**APPLICATION NO. A/NE-TK/837 FOR PERMISSION  
UNDER SECTION 16 OF THE TOWN PLANNING ORDINANCE**

Annex 1 - Response to Comments Table

Section 16 Application for Temporary Public Vehicle Park (Private Cars Only) with Ancillary Electric Vehicle Charging Facilities and Ancillary Solar Panels and Associated Filling of Land for a Period of 3 Years at Lot No. 241 in D.D. 23 at Ting Kok, Tai Po, New Territories

Annex 2 : Indicative Layout Plan

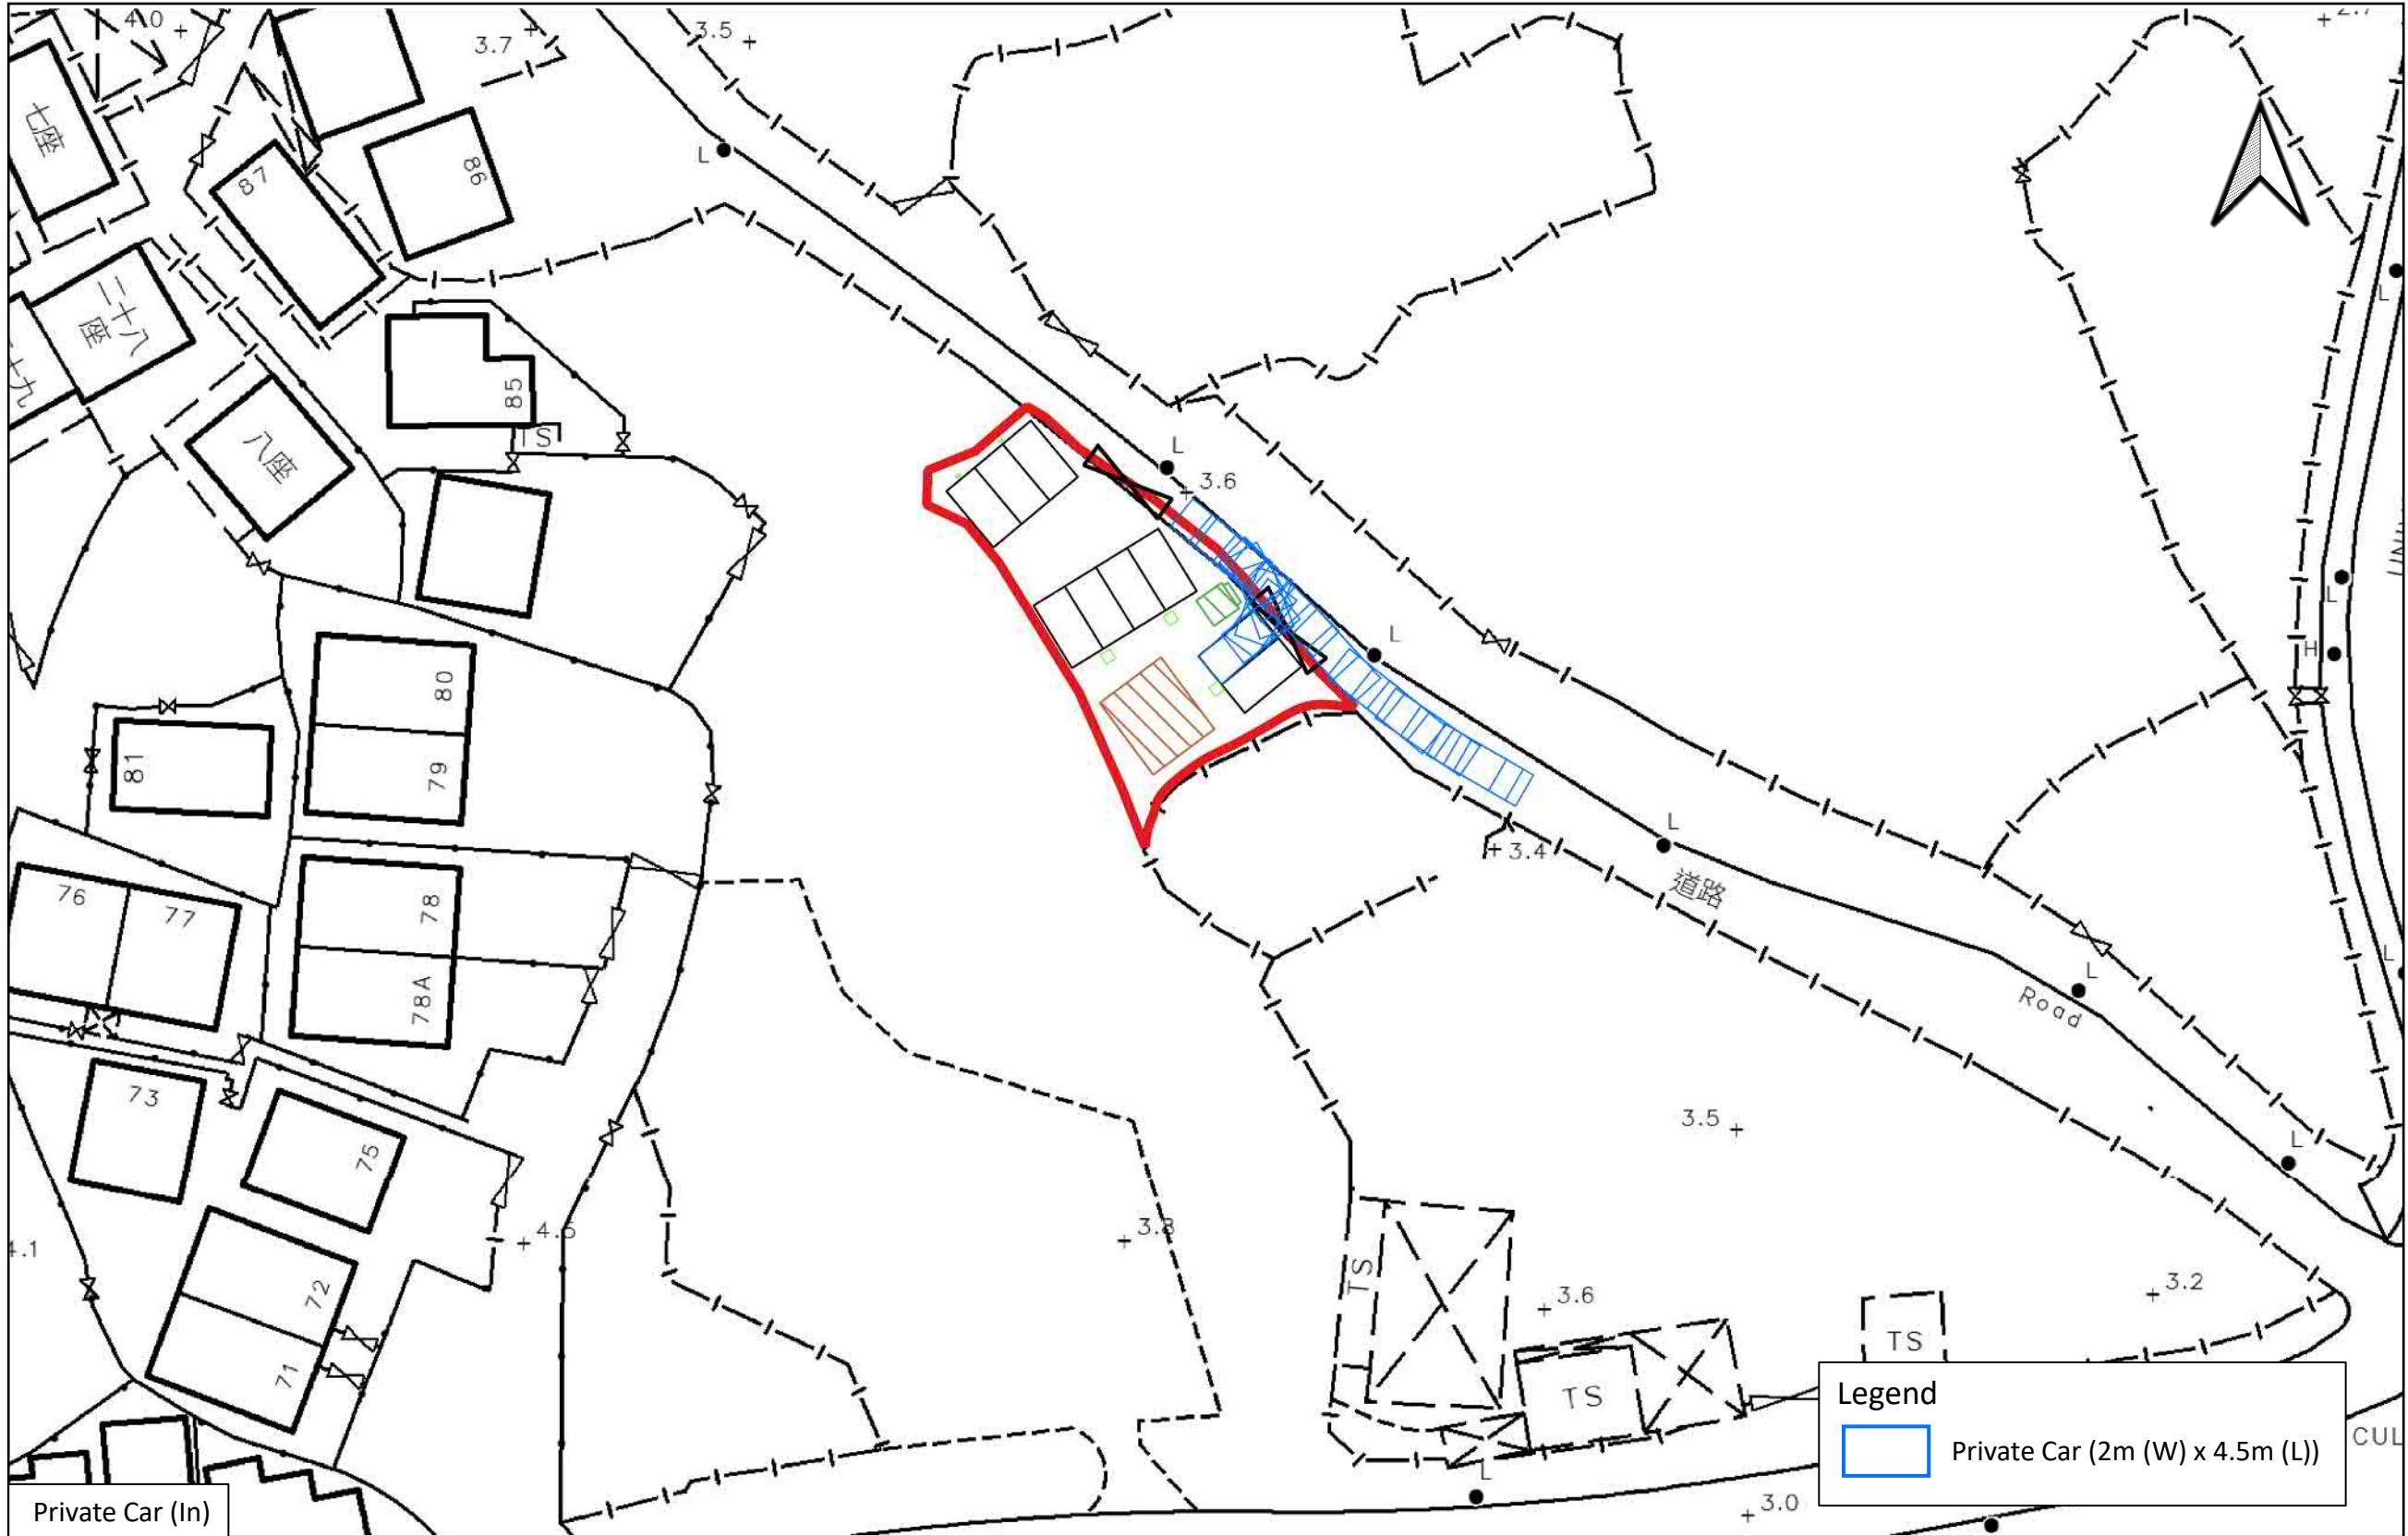
No.	Comments Received	Our Responses
1.	<i>Comments from Environment and Ecology Bureau received on 17 July 2025</i>	
a	<p>It is noted from Para. 3.5.1 of the Supporting Planning Statement (P.22 out of 45 of the pdf) that “among the 9 nos. of parking space, 7 will be the 200kW charging point (fast speed) and the remaining parking spaces will be 7kW charging point (medium speed)”. However, it appears from Annex 2: Indicative Layout Plan (P.38 of 45) that there are only 5 EV chargers (2 nos. of 7kW medium chargers and 3 nos. of 200kW fast chargers). Please clarify and advise the number of parking spaces that would (i) provide with medium charging (7kW or above) and their respective rated output power; (ii) provide with fast charging (100kW or above) and their respective rated output power.</p>	<p>To clarify, three parking spaces shall be provided with medium charging (7kW) and the remaining six parking spaces will be provided with fast charging (200kW).</p> <p>A revised <b>Annex 2</b> is attached for further clarification.</p>
